UNITED STATES PATENT AND TRADEMARK OFFICE

APPLICATION NO.	FILING DATE	FIRST NAMED INVENTOR	ATTORNEY DOCKET NO.	CONFIRMATION NO.
10/087,731	03/05/2002	Nobusige Arai	2936-0151P	1577
2292	7590	09/10/2004	EXAMINER	
BIRCH STEWART KOLASCH & BIRCH PO BOX 747 FALLS CHURCH, VA 22040-0747			STINSON, FRANKIE L	
			ART UNIT	PAPER NUMBER
			1746

Office Action Summary	Application No.	Applicant(s)	
	10/087,731	ARAI ET AL.	
	Examiner	Art Unit	
	FRANKIE L. STINSON	1746

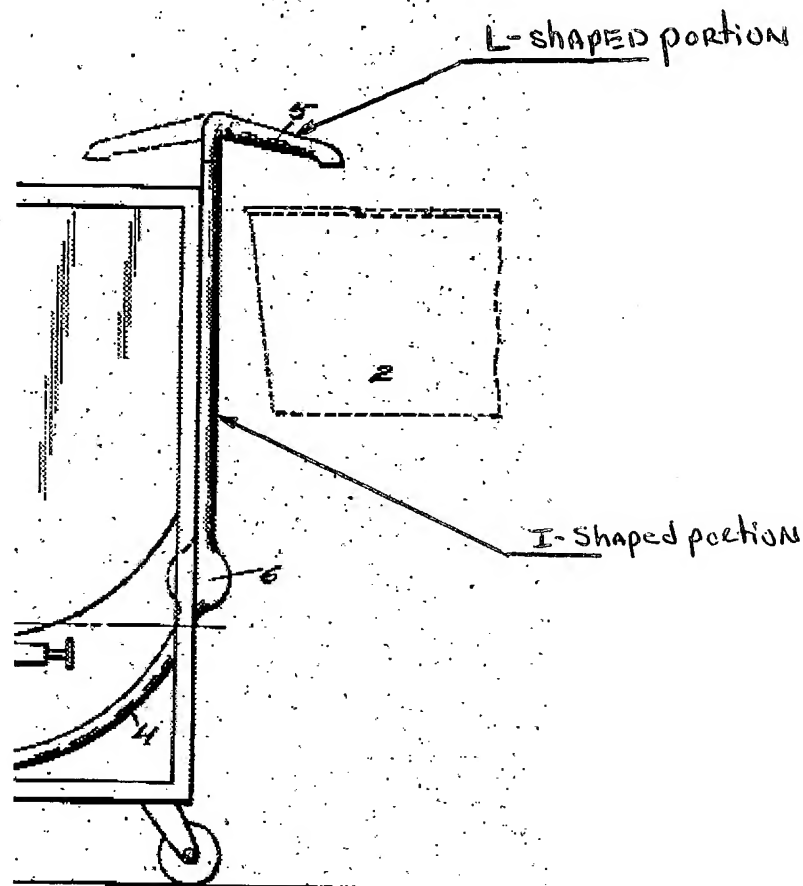
Re claim 1, Culver is cited disclosing a washing machine having a spout/nozzle fitted to the washing machine by a first and second portion so as to be movable between an in-use position and a non-use position different from the in-use position when not in use that differs from the claim only in the recitation of the partial washing apparatus fitted to the machine by a first and second portion coupled by a ball member. Japan'793 is cited disclosing in a washing machine a partial washing apparatus washing dirt from articles by means of supersonic vibrations. Therefore, given the teachings of Japan'793, it would have been obvious to one having ordinary skill in the art to modify the spout of Culver to be a partial washing apparatus for removing dirt by supersonic vibrations as taught by Japan'793, for the purpose of pre-treating particularly soiled portions of (laundry) articles. As for the first portion and second portion being coupled by a ball member to place the partial washing apparatus in an in-use position and a not-in-use

position, please note the use of a ball member is deemed to be a functional equivalent of the swivel joint in Culver (see MPEP 211.06, "SUBSTITUTING EQUIVALENTS KNOWN FOR THE SAME PURPOSE"). Re claim 52, Culver discloses the substantially L-shaped and I-shaped portions (see notations in the figure above).
